SERVICE BULLETIN

APPLICABILITY: 2012-16MY Impreza 2.0L Models
 2015MY-2016MY WRX and STI Models
SUBJECT: Rattling Sound from Rear Package Shelf Area

NUMBER: 12-189-15R
DATE: 09/23/15
REVISED: 07/26/16

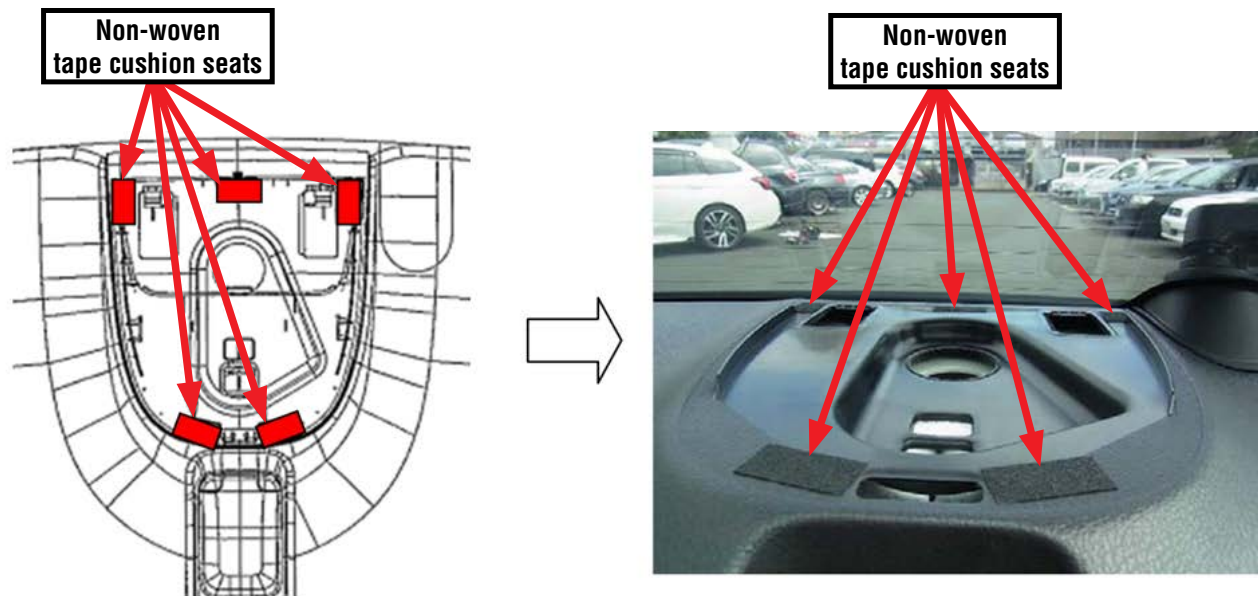
- If the rattle sound is confirmed and determined to be coming from the center stop lamp in the rear package shelf, prepare 5 pieces of non-woven tape material (p.n. **SOA963W110**) 15mm X 30mm. Remove the lamp assembly following the procedure in the applicable Service Manual. Apply the non-woven tape (cushion seats) to the lamp mounting areas of the package shelf as shown in the illustration and photo below. Reinstall the lamp assembly in reverse order of removal.

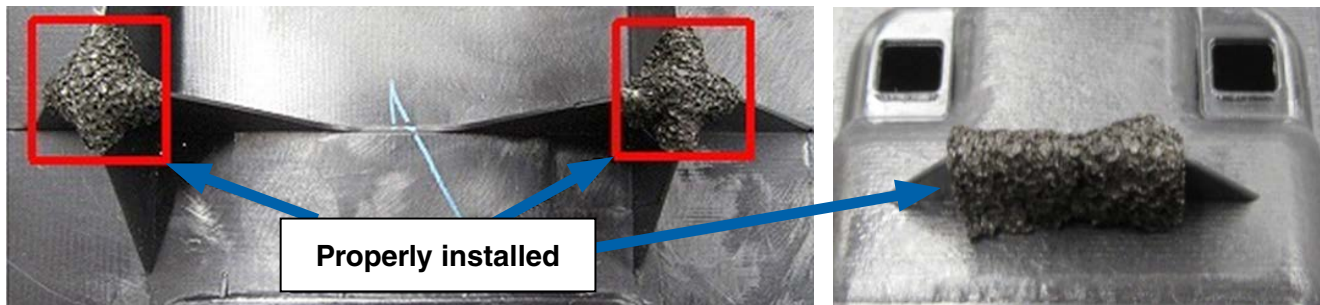
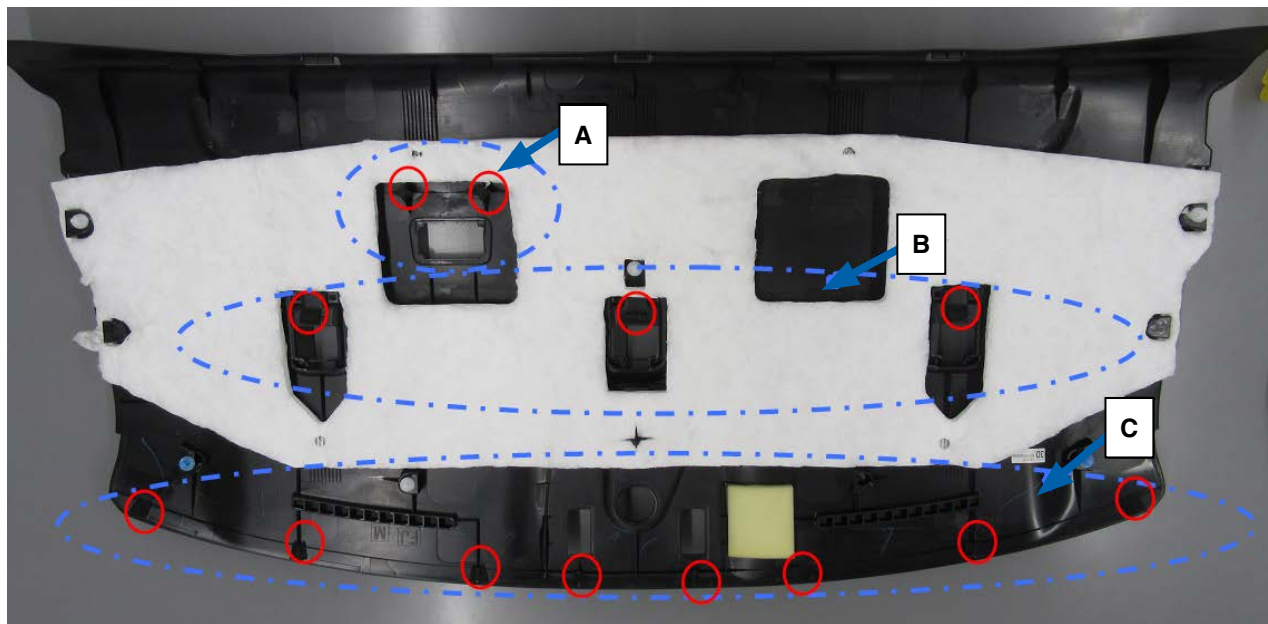
- If the rattle sound is confirmed and determined to be caused by the rear package shelf contacting the rear glass, order a self-adhesive EPT foam tape “kit” (p.n. **63599AJ000**). Remove the package shelf following the procedure in the applicable Service Manual. Using the 3mm X 5mm X 650mm long strips from the kit, apply the EPT foam tape to the rear edge of the package shelf as shown in the illustration below. Each side will use approximately 600mm of the 650mm long strip. In addition, apply the 5 non-woven tape (cushion seats) as referenced above to the center stop lamp mounting areas of the package shelf at this time. Reinstall the package shelf and center stop lamp assembly in reverse order of removal.

- **IMPORTANT:** While the package shelf is removed, always inspect the underside of for missing or misaligned EPT foam tapes which must be applied to the support rib and stand portions. This will insulate the package shelf from the vehicle body. The photo below shows all the locations in areas **A, B & C** (circled in red) which should be inspected and have EPT foam tape applied as needed before reinstalling the package shelf. Example photos of how the EPT foam tape should appear after application are also supplied.
